1999 Ford Mustang GT V8-4.6L SOHC VIN X

LEFT HAND REAR QUARTER AREA - CREAKING NOISE

99-21-8

10/18/99

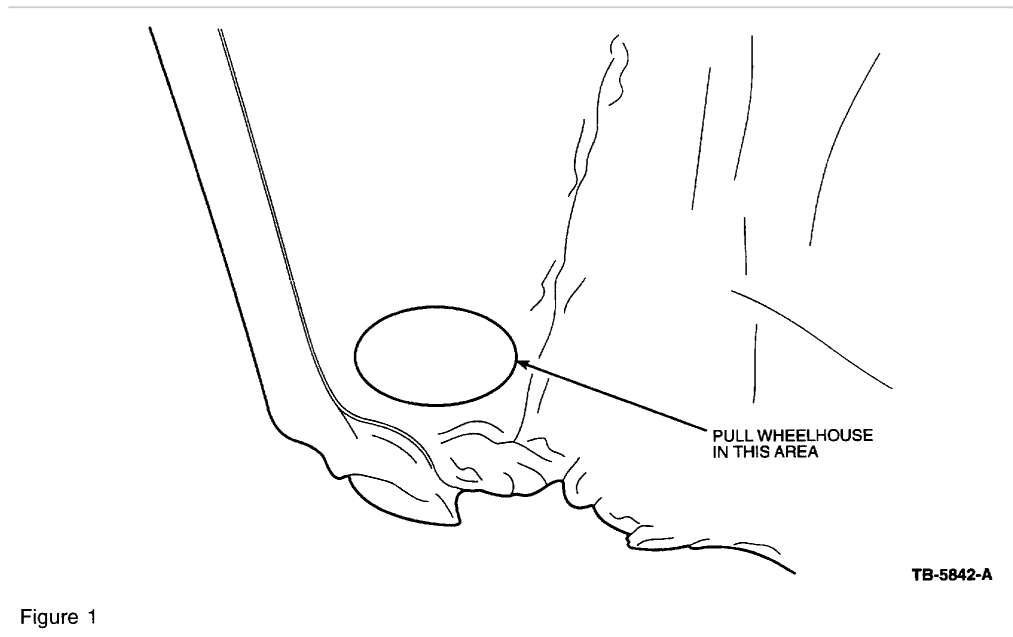
A "creaking" noise from the LH rear quarter area when going over bumps may be heard on some vehicles. This may be due to contact between the inner rocker panel and the outer wheelhouse of the LH rear quarter area.

1. Remove the left rear wheel.
2. Drill two (2) holes using a 1/8" drill bit into the wheelhouse (approximately 25 mm (1") above the lower flange and 25 mm (1") outboard of the wheelhouse seam).

3. Using a dent puller, pull the wheelhouse metal away from the rocker panel (Figure 1).
4. Redrive vehicle to make sure concern is repaired.
5. If concern is still present, repeat Steps 2-4 with two (2) more holes approximately 19 mm (3/4") outboard of the wheelhouse seam. Do not drill more than a total of four (4) holes.
6. Spray over the holes with Super Seal Anti-Corrosion Compound (F3AZ-19515-SA or equivalent meeting Ford Specification ESR-M7C54-A).
